Illustrated Parts List - IPL Update

H435 II

1. Oil hose

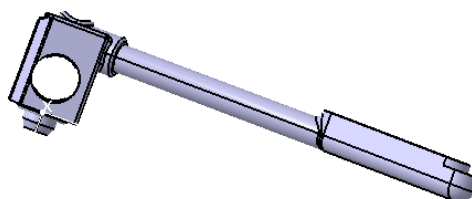
1. Updated Oil Hose 544 08 42-02 added. Sealing knob removed to simplify assembly.
